25-118ARB-MPR

ARB Submission Set Date: 12/18/25
① Revision Date: 01/14/26
② Revision Date: 01/28/26
③ Revision Date: 02/12/26

Project Title: 25-118ARB-MPR
Project Address: 20 North Street ARB Revision
Design Firm: Bass Studio Architects
Sheet Title: Cover
20 North Street Dublin, Ohio 43017

Review Elements Narrative:

2 View Proposed ALTERNATE 1

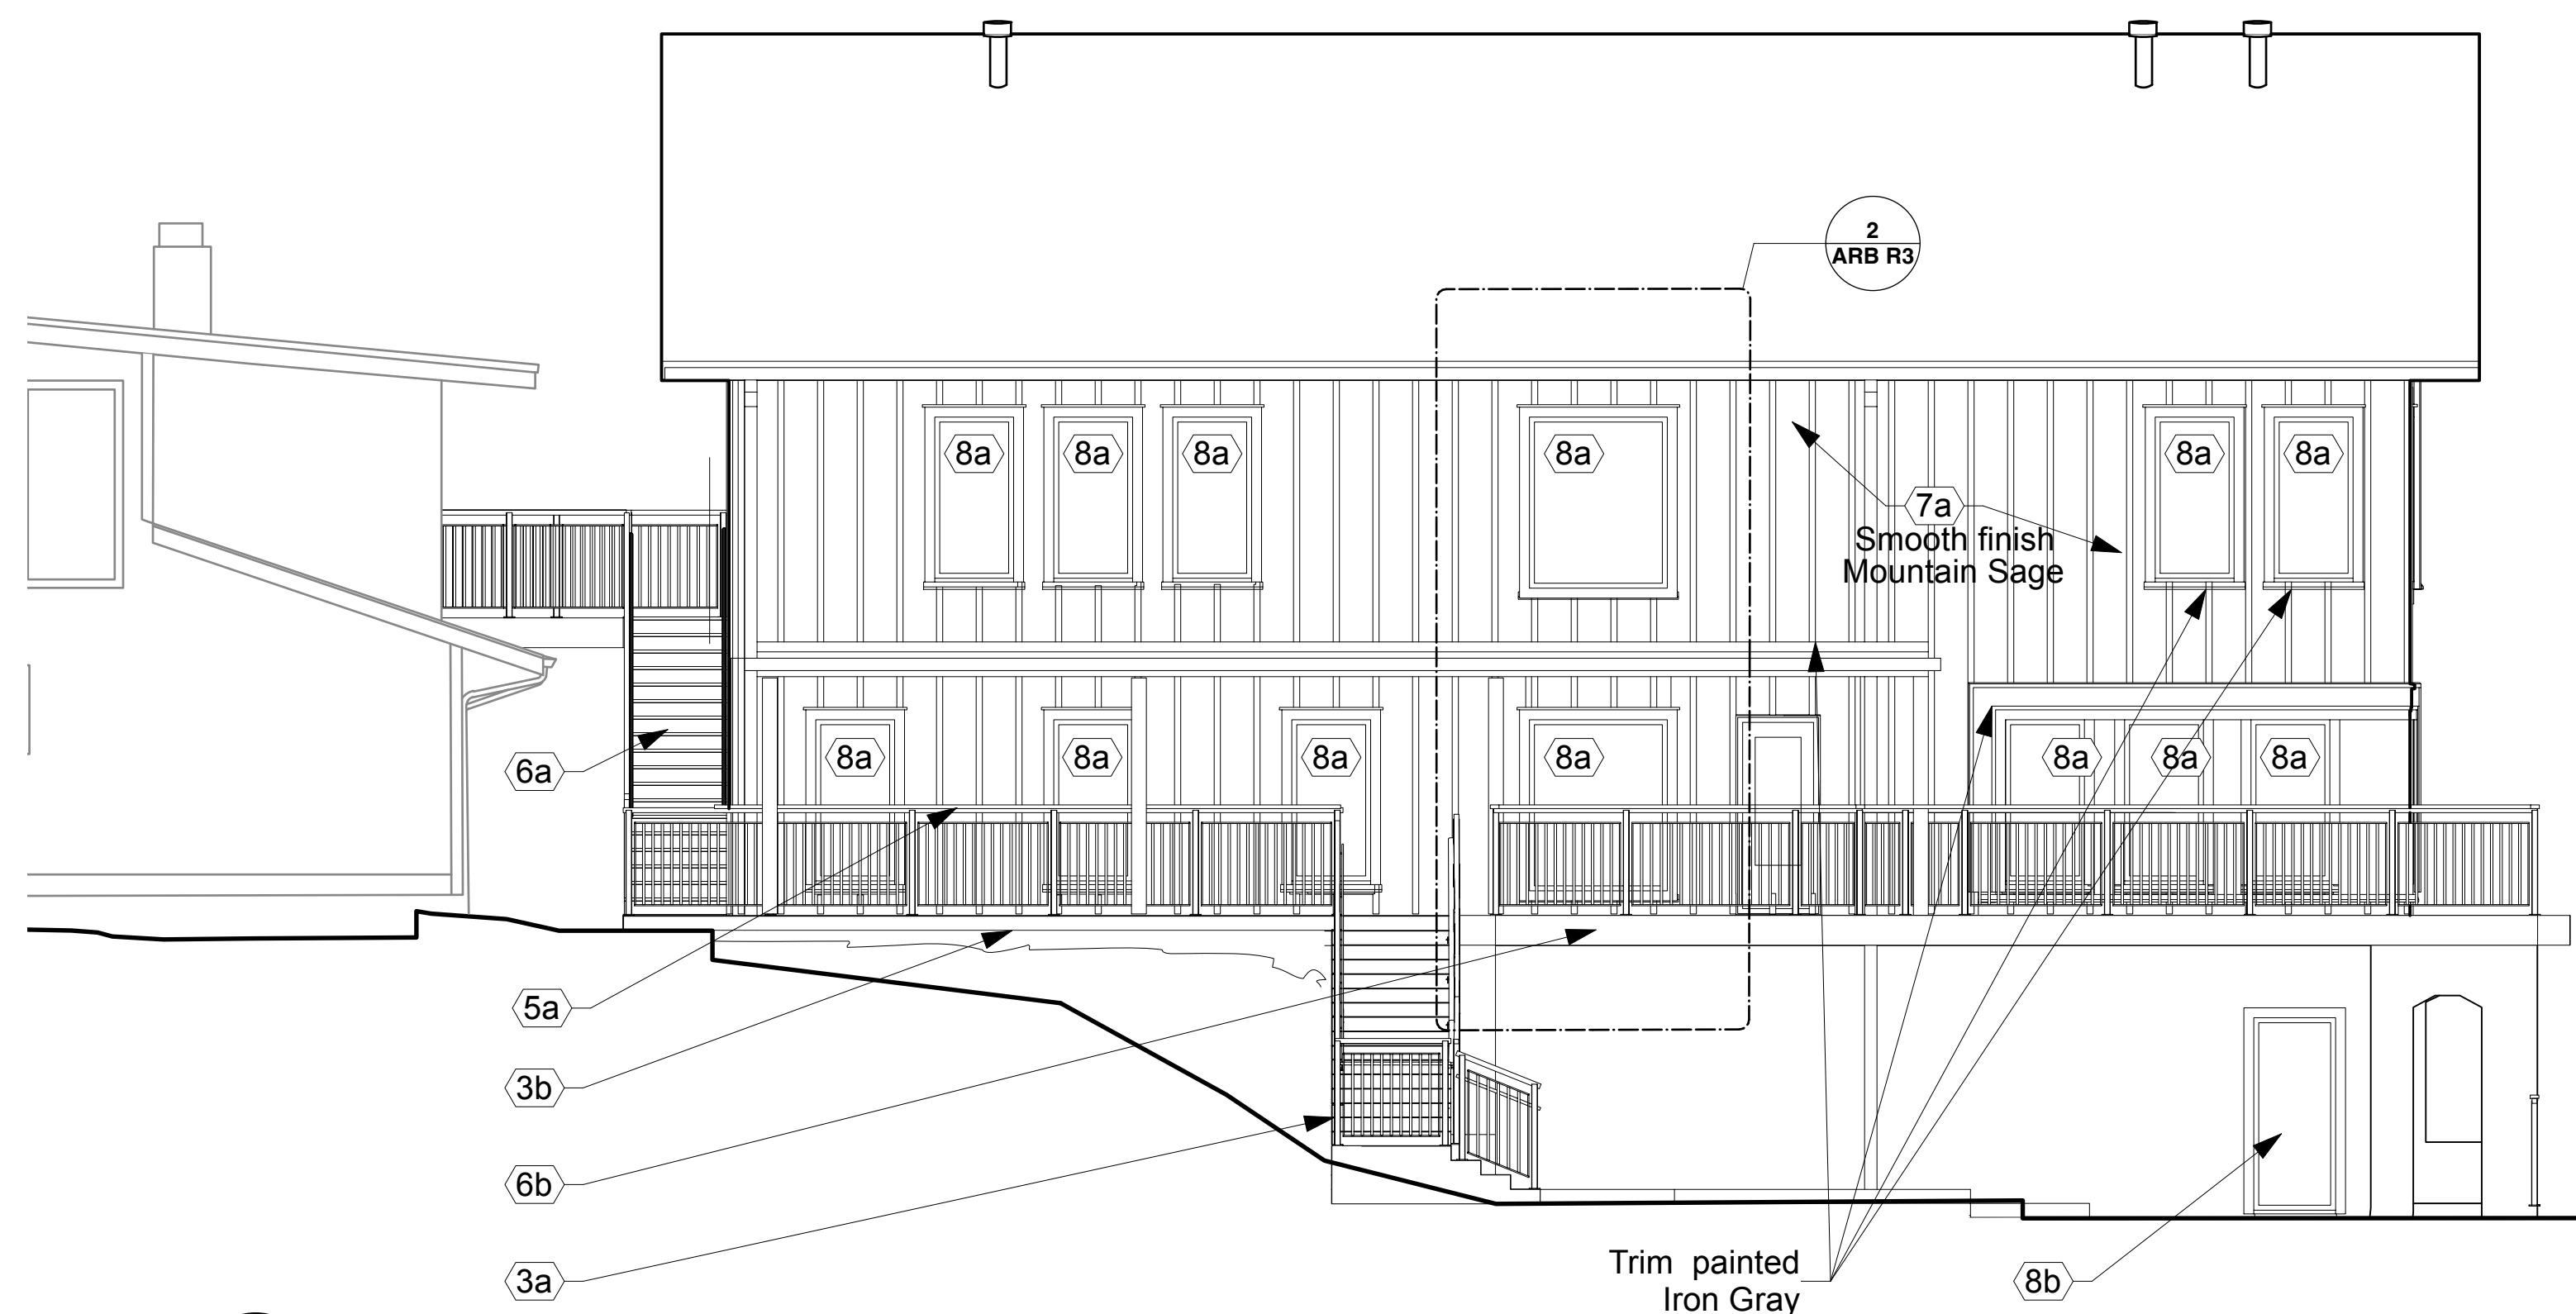
2 Central Window Configuration

The windows were initially submitted and approved with an existing stair condition inside in which the stair was removed from the exterior wall by an odd small distance. Because of this and the reverse condition of the stair a decision was taken to rebuild the stair to bring the stair closer to compliance with the current building code, and eliminate the odd residual space at the wall. The landing is moved tight with the exterior wall. As a result, we need to reconfigure the central window pair condition as the landing disrupts the original lower window.

The upper window is extended/enlarged down to just above the landing of the new stair. The proposed solution is one large window. The window is the same width as originally proposed and double the height. We appreciate the hierarchy and focus created in the facade composition by the large window. We also appreciate the configuration, with the appropriate trim, reads like an over scaled double hung window; a ubiquitous image in the district. This configuration is also the most rational on the interior experience.

REVISED CENTRAL WINDOW
Refer to 3/ARB R3

4 South Elevation ALTERNATE 1

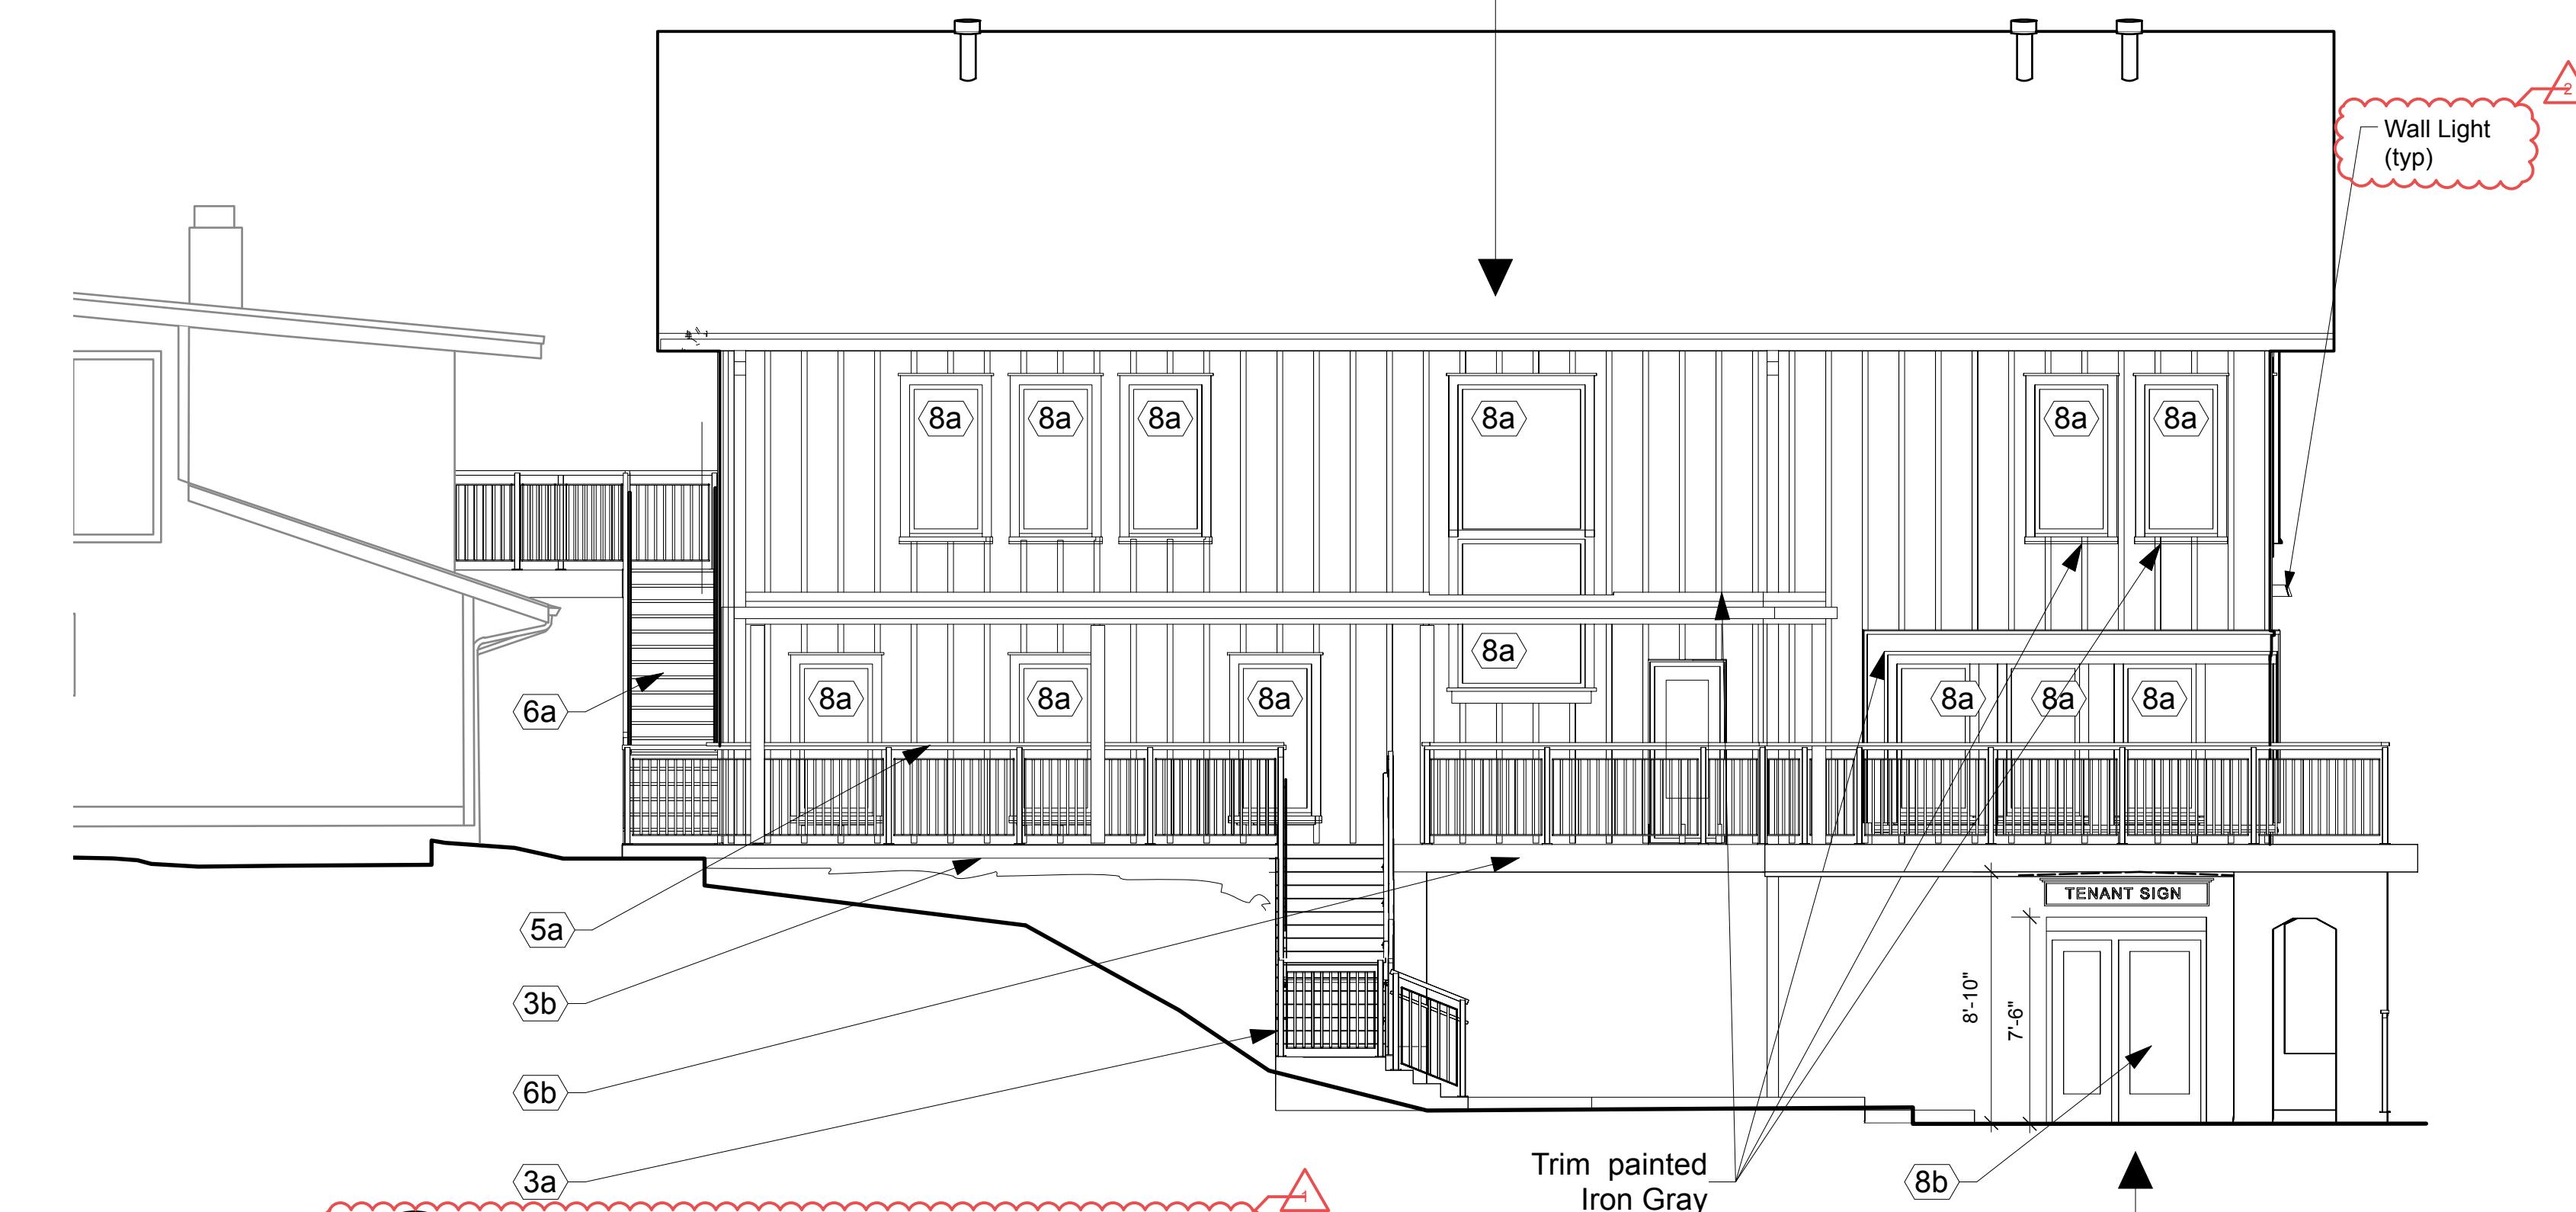
1 Lower Level Door

New design element. Tenant Driven addition of a street door entry. The Lower Level Entry presents a conventional merchant or business entry in relation to the street. The door is given more emphasis as a "street door" with the addition of the sidelight. The entry resolves to a standard punched opening with stone above carrying the sign. The sign is a standard Tenant sign as described in the Master Sign Plan. This entry will be unified with the signage plan for the whole complex and not draw attention away from the main building entry framing.

The entry will be protected from the weather by a "concealed" awning or simple diverter membrane. The slope of the membrane is concealed by a small added trim. The trim is continuous to natural break points. Lighting for this entry is recessed into the deck. Refer to 4 and 5/ARB R3 sheet.

NEW STREET DOOR
Refer to 8/ARB R3

4 North Elevation
Scale: 3/16"=1"

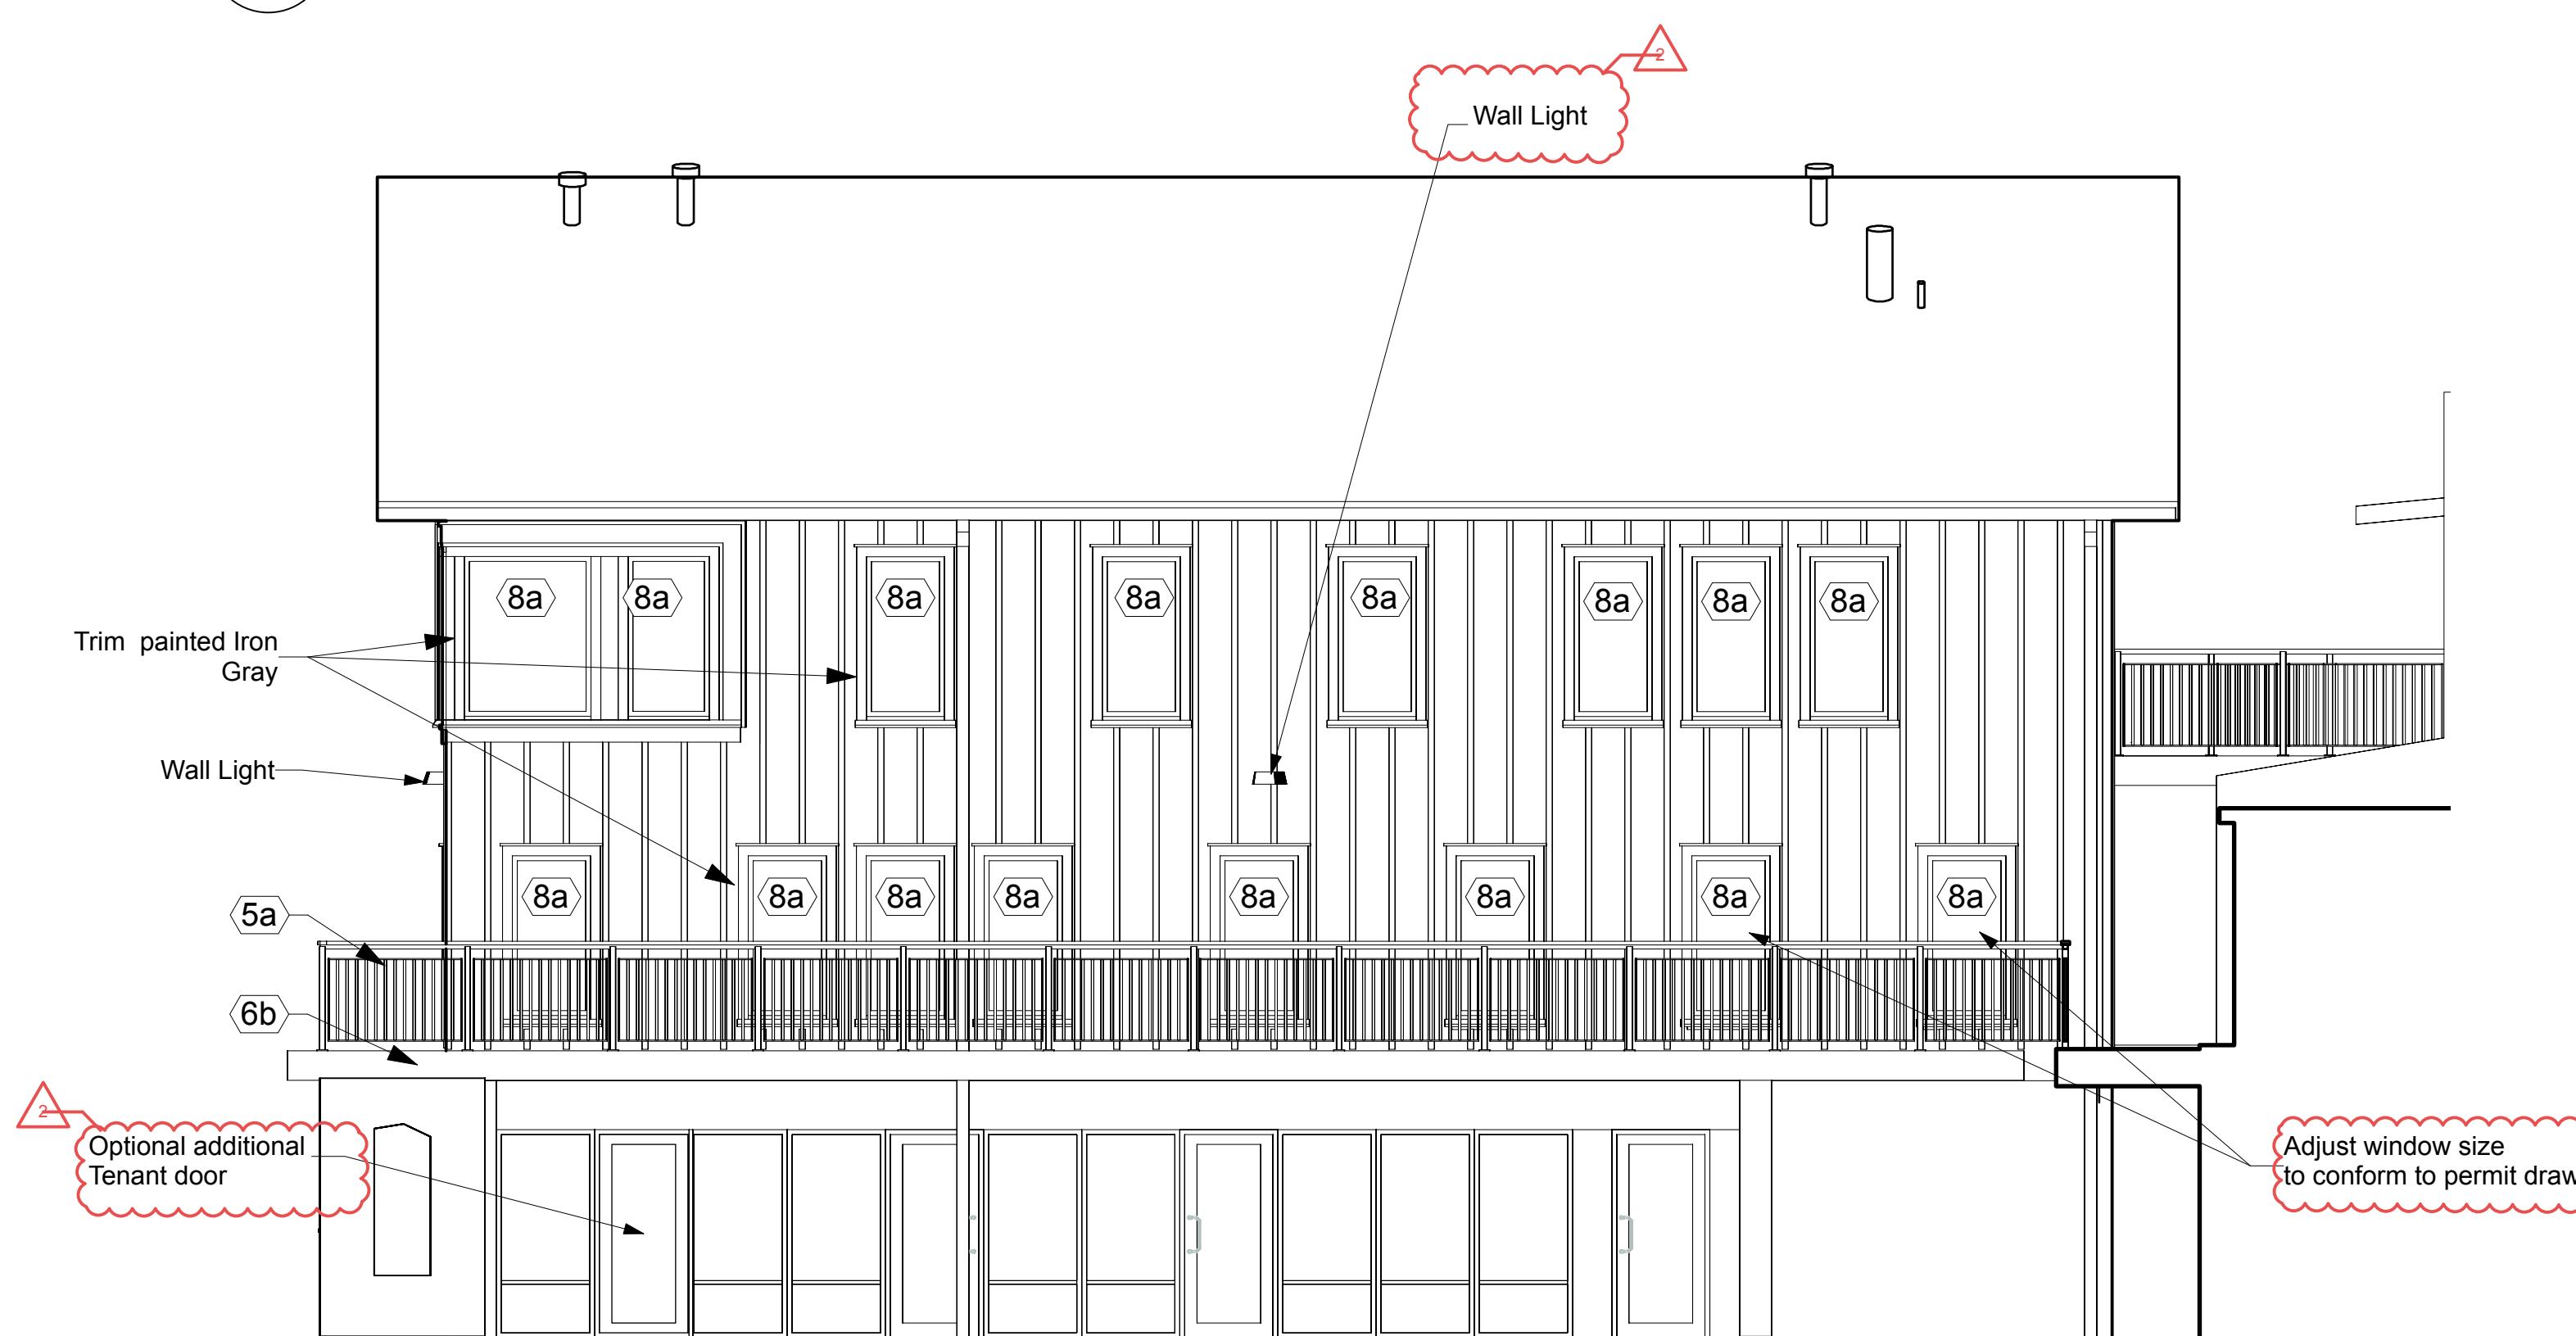
4 North Widows First Floor.

Adjust the size of the first windows on the west end of the north facade to conform to permit drawing adjusting to match all the other standard windows. Please refer to 4/ARB R7.

5 North Door Basement

An optional, additional Tenant door is shown to conform to permit drawing. Please refer to 4/ARB R7.
